ENGINEERING ORDER

1. ENGINEERING ORDER NO. 2012C0714-T

2. DWG TITLE	3. DWG CAGE CODE	4. DWG NO.
EMERGENCY OXYGEN PRESSURE REDUCER ASSEMBLY TYPE NA	99251	1659879-1

OTHER COMMENTS: This EO adds Item Unique Identification (IUID) requirements to the drawing

5. DESCRIPTION OF CHANGES/REMARKS

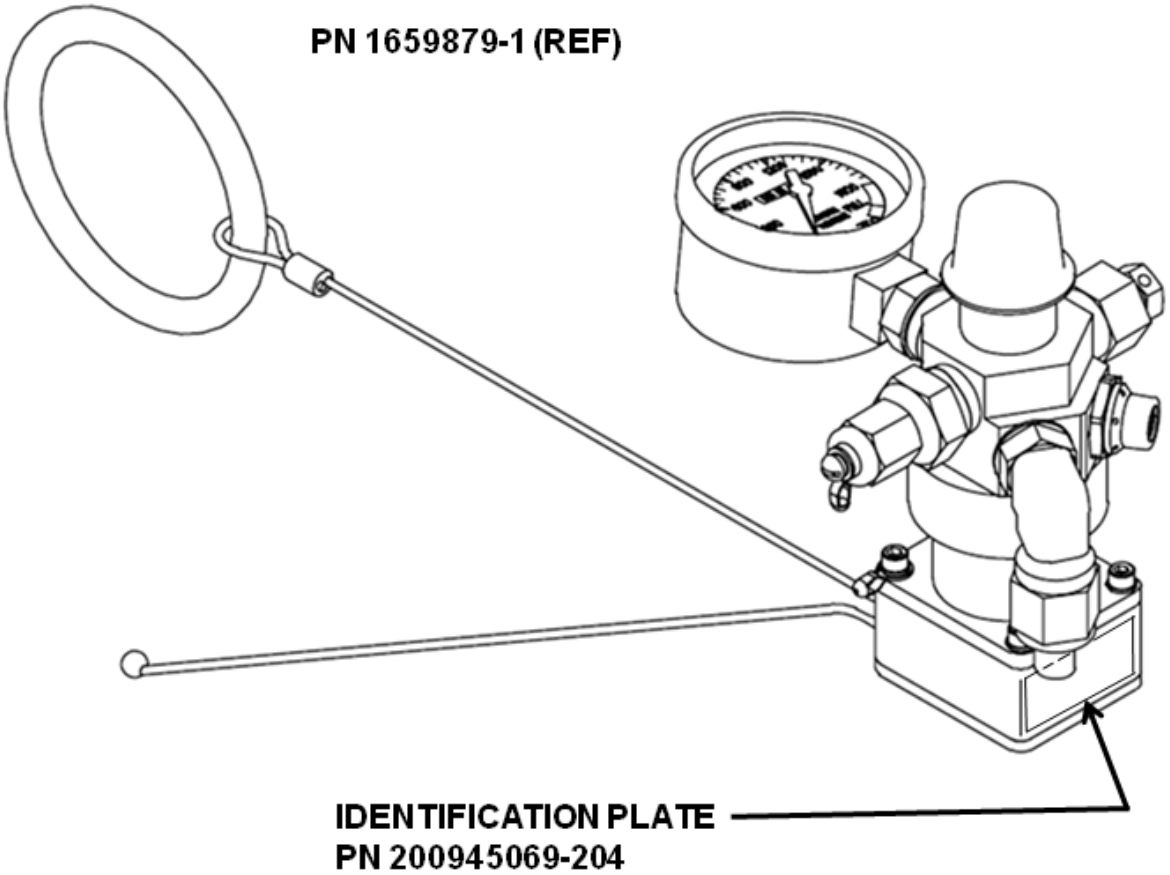
- F-16 Aircraft Emergency Oxygen Pressure Reducer Assembly (PN 1659879-1) shall be marked with a Unique Item Identifier (UII). (REF: MIL-STD-130)

- If no UII symbol is present, fabricate new identification plate (200945069-204) to replace existing identification plate/label.

- New UID identification plate will be located in the same location as existing plate/label. See sketch/photo on page 2, AF form 3926.

- After attaching IUID plate to end item, apply a thin overcoat to IUID plate ensuring the plate edges are sealed, using 1A20, 1A33 or equivalent Polyurethane Conformal Coating, per manufacturer's instructions. REF: MIL-I-46058C
